POWERTECH (USA) INC.

RE: Revised Technical Report (TR); Powertech (USA) Inc.'s Proposed Dewey-Burdock Project; Docket No. 40-9075

CHANGE INDICES

TR RAI 6.1-4

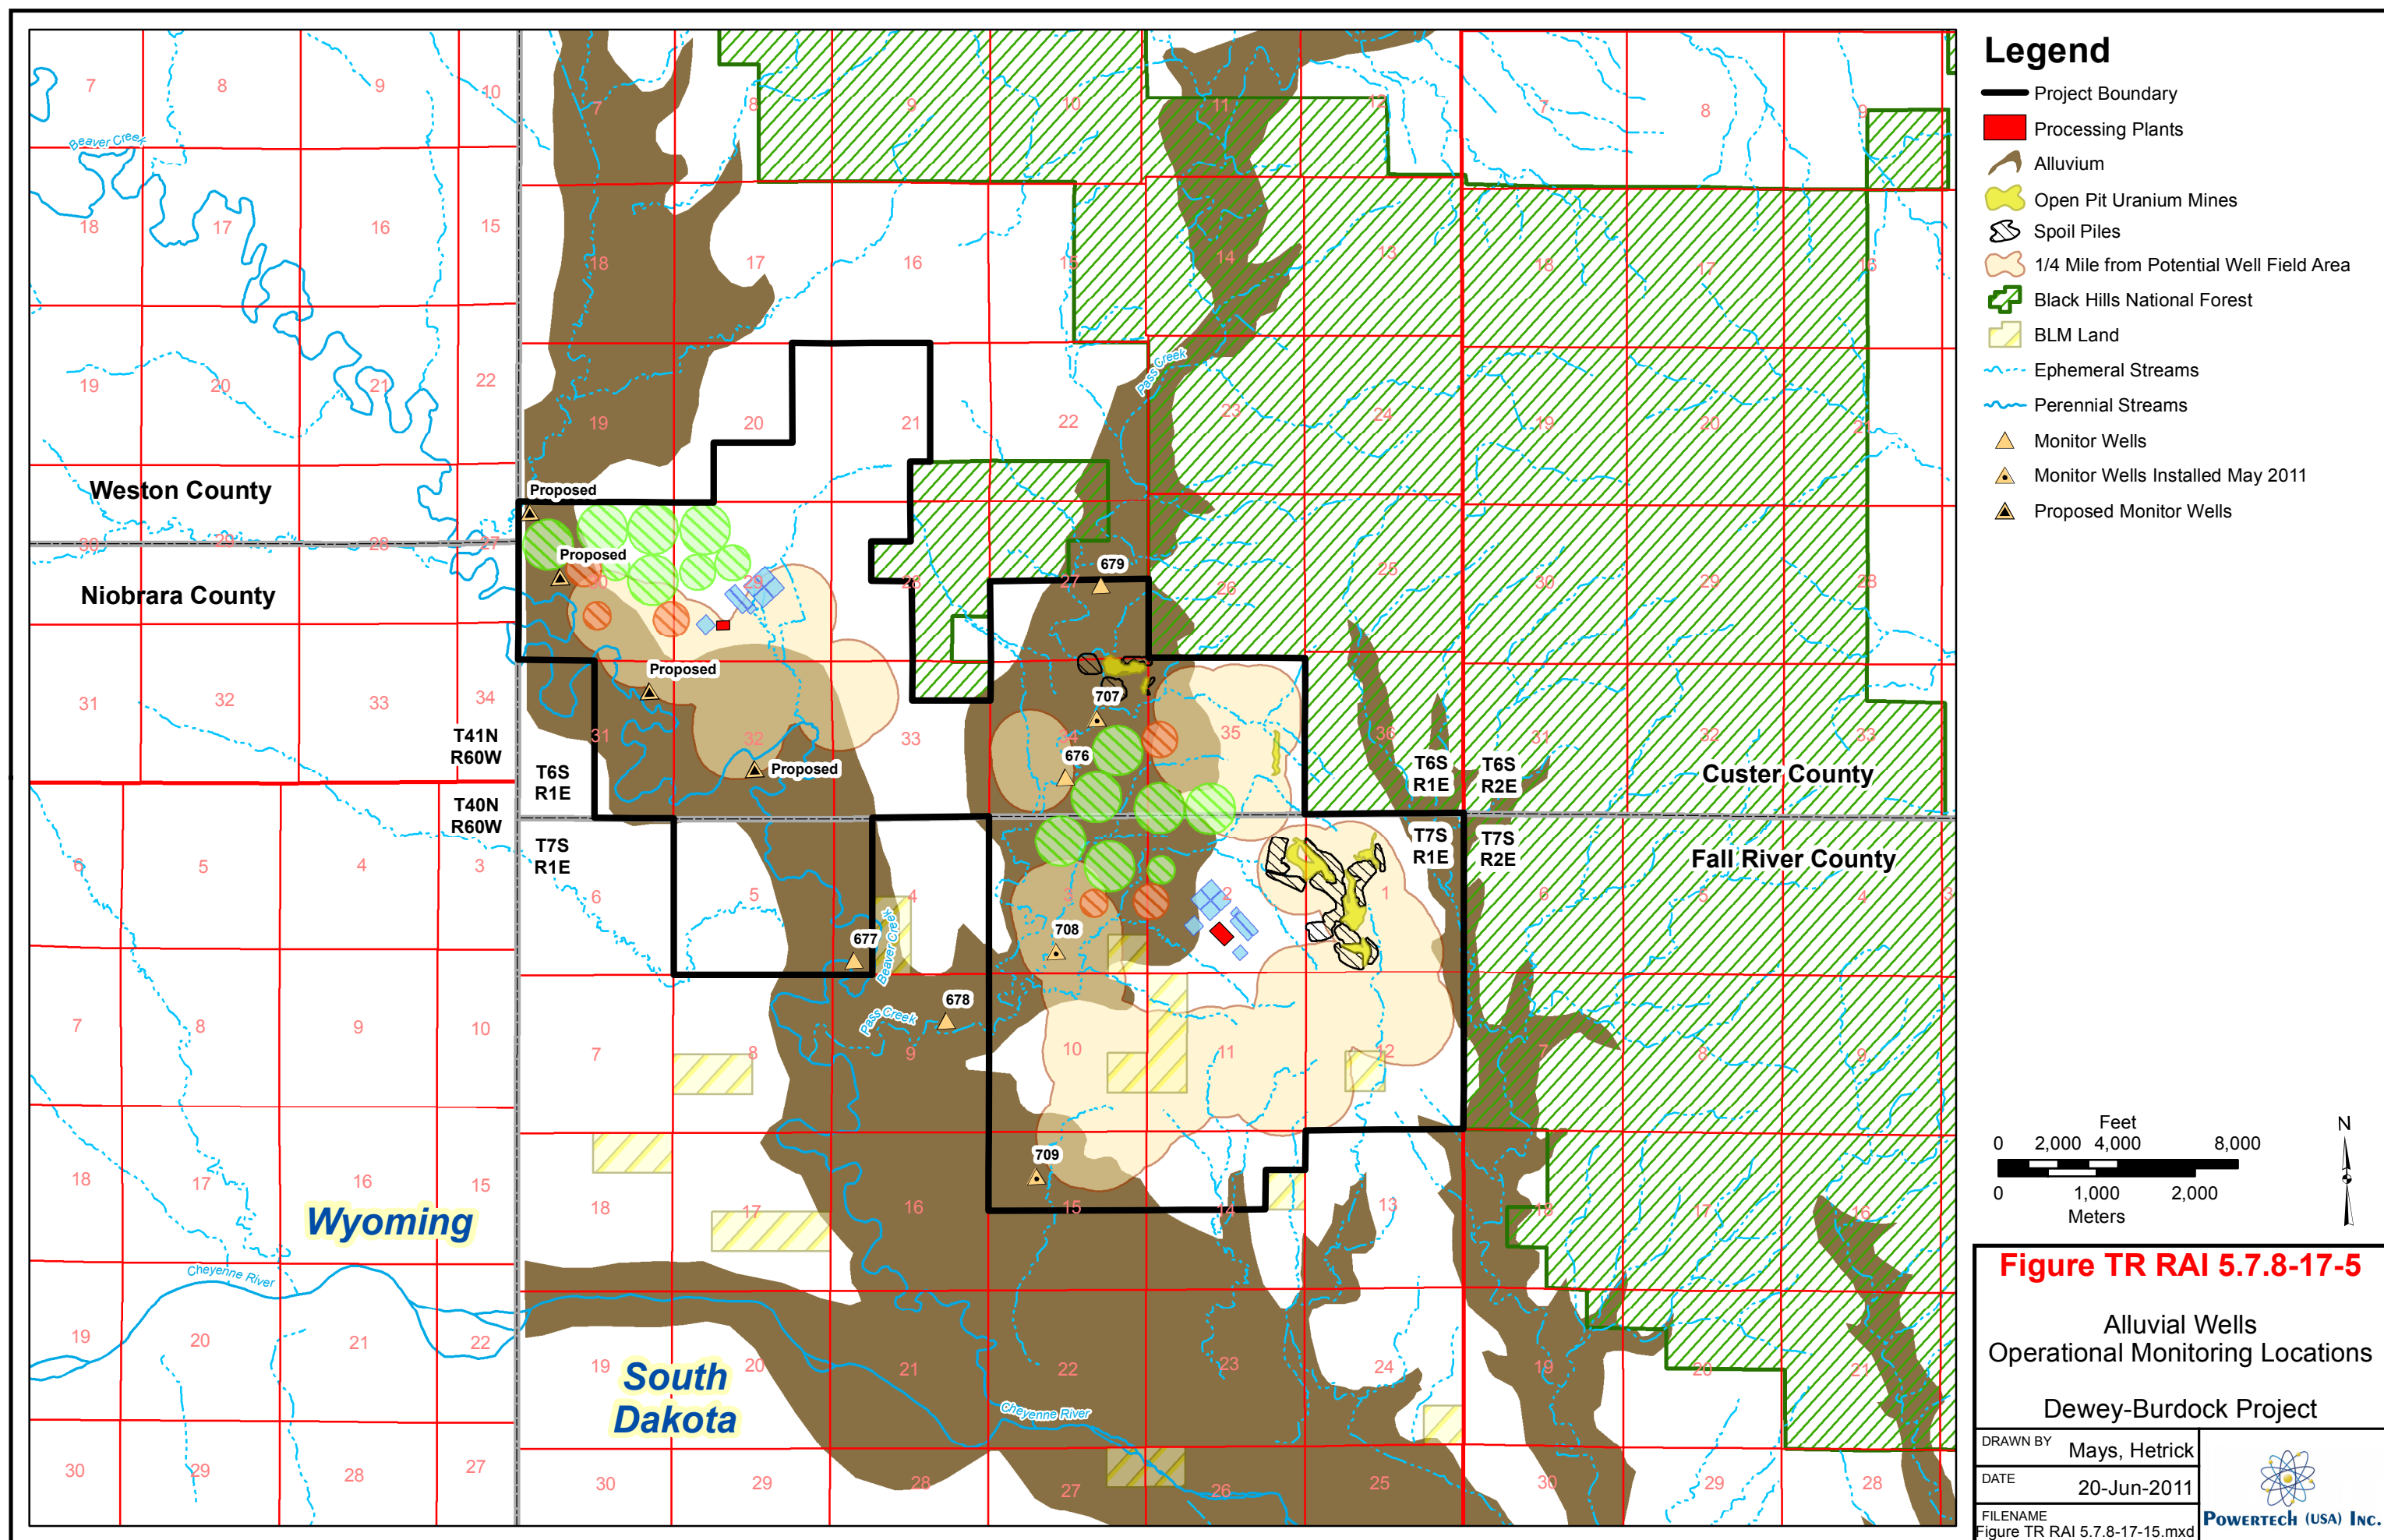
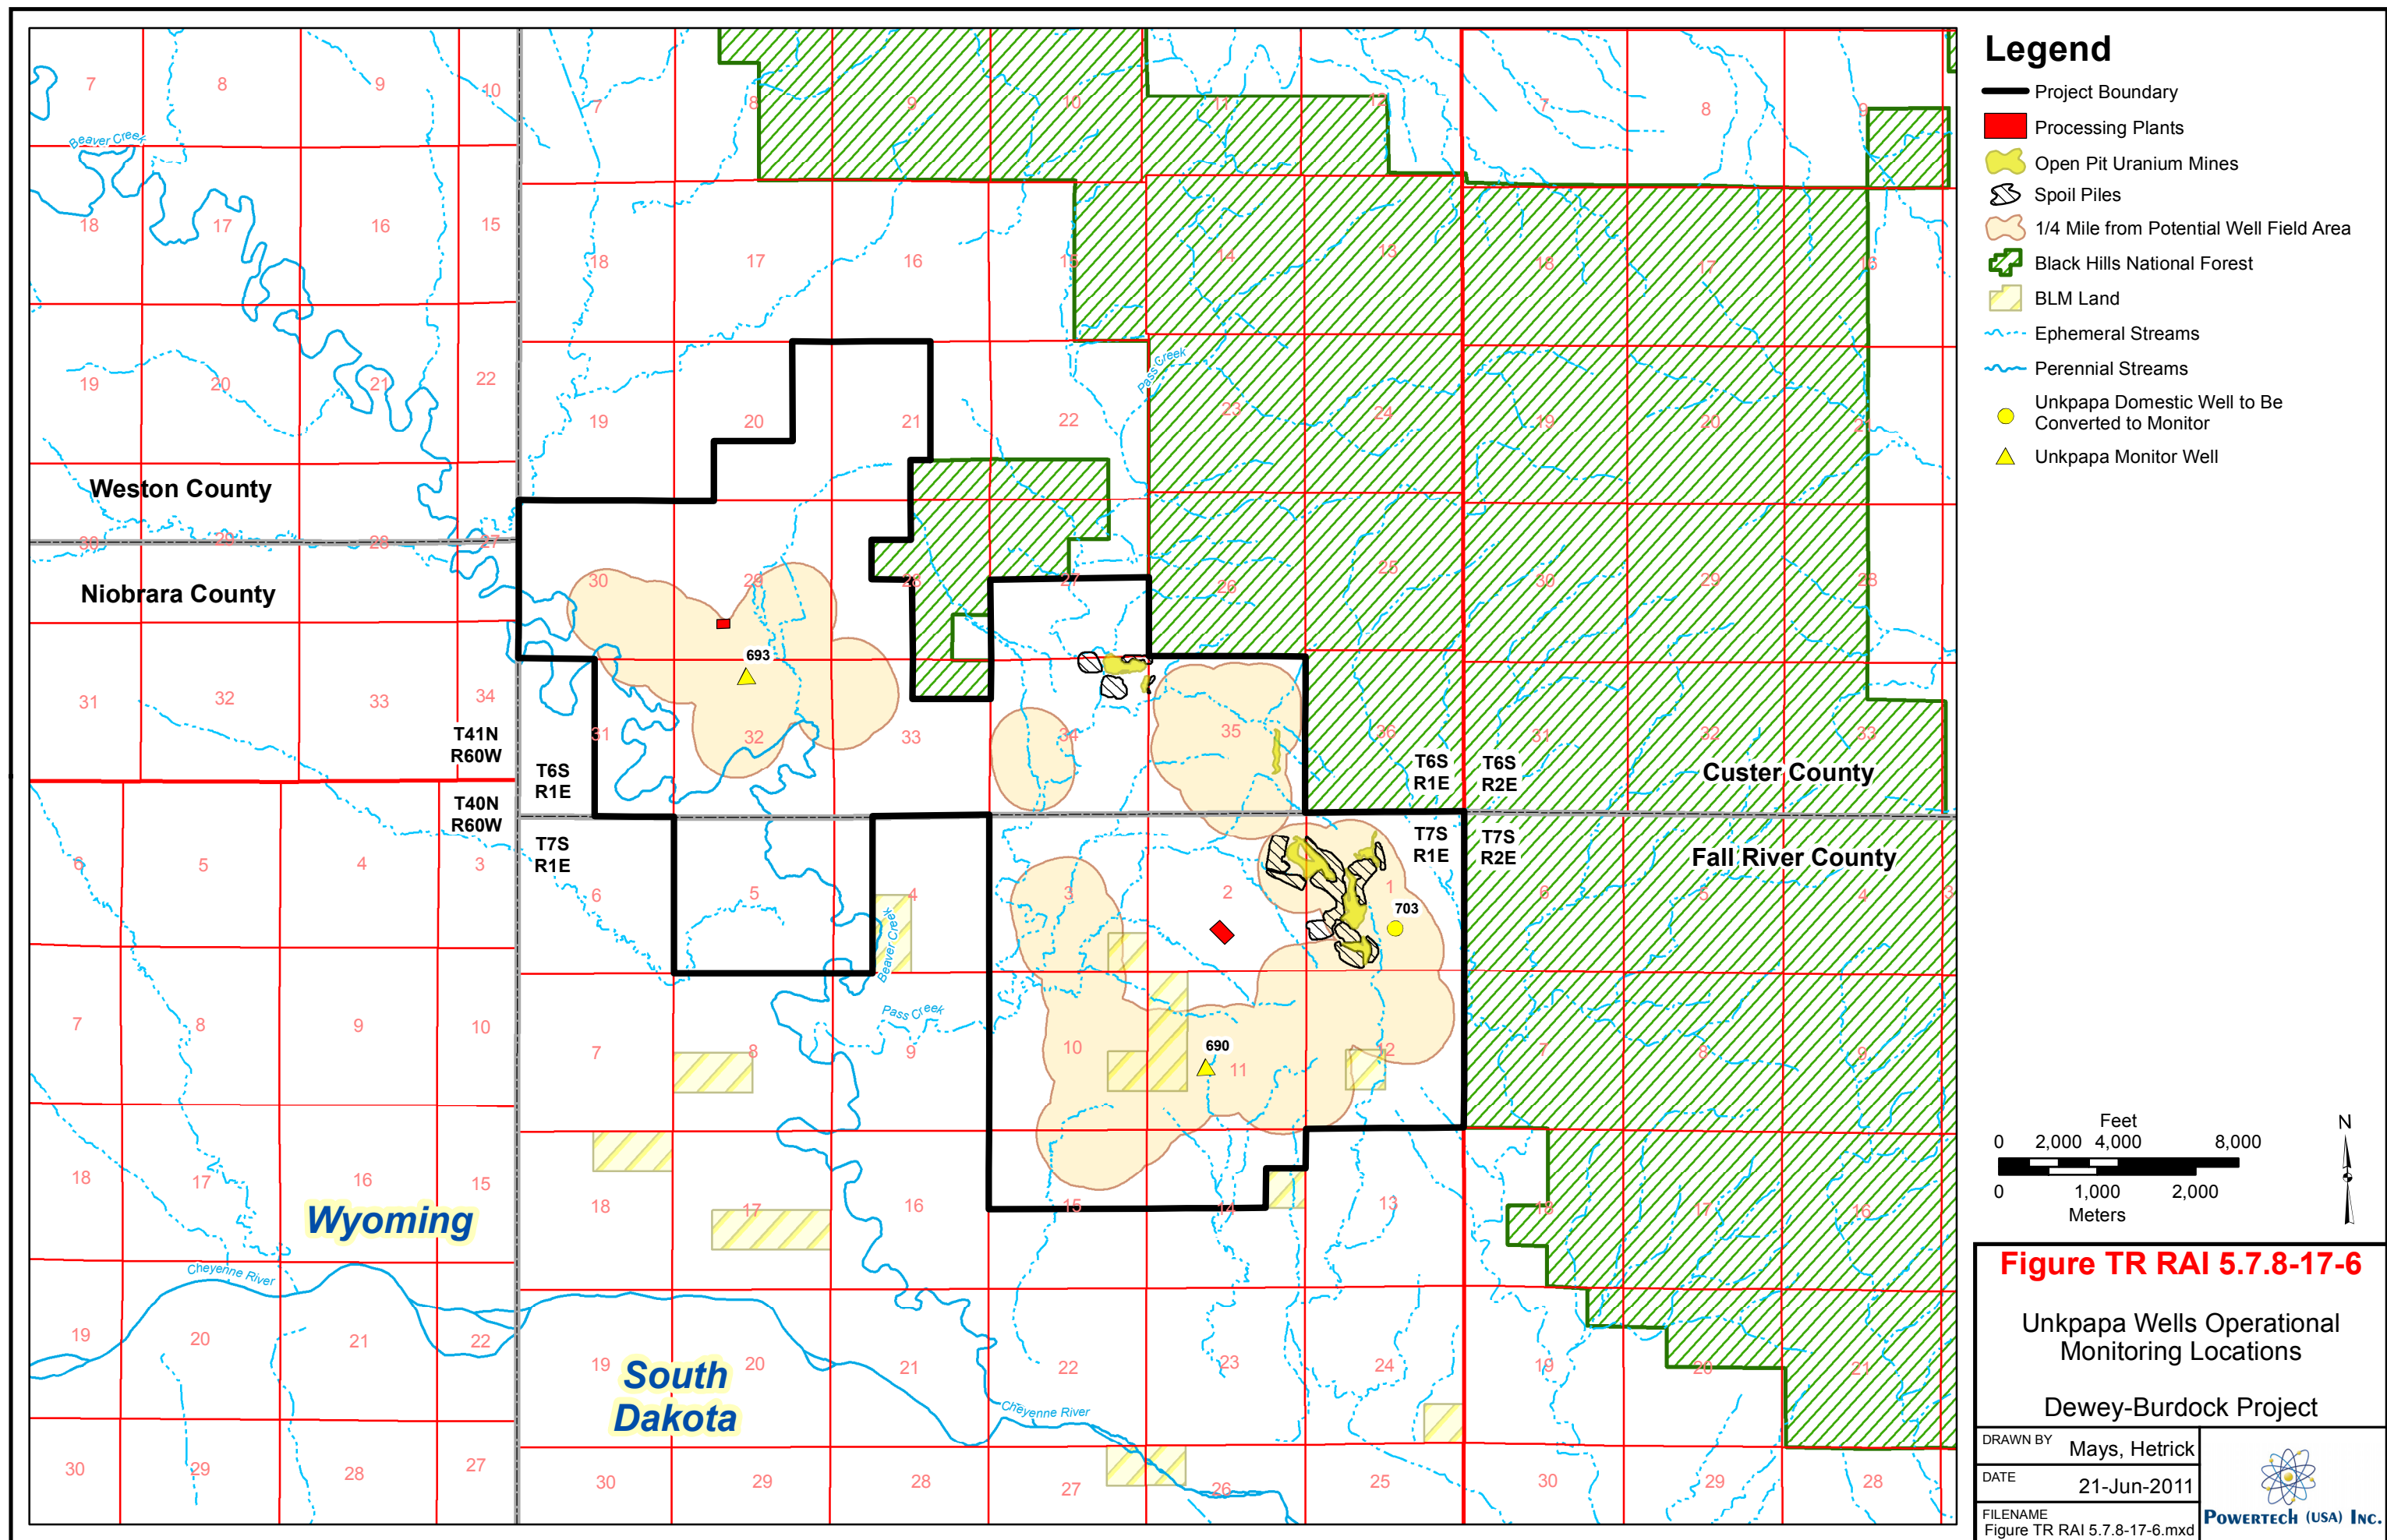
Section 5.7.8 of the TR states, "Quarterly samples will be collected from drinking water and livestock wells, included in the groundwater sampling sites as shown in Figure 5.7-10." This statement implies there are more proposed well sampling locations than what is shown in Figure 5.7-8. NRC staff notes that numerous Inyan Kara wells in Appendix 2.2-A are close to well fields within the license boundary and are not included in Figure 5.7-10. Please specify all water well sampling locations.
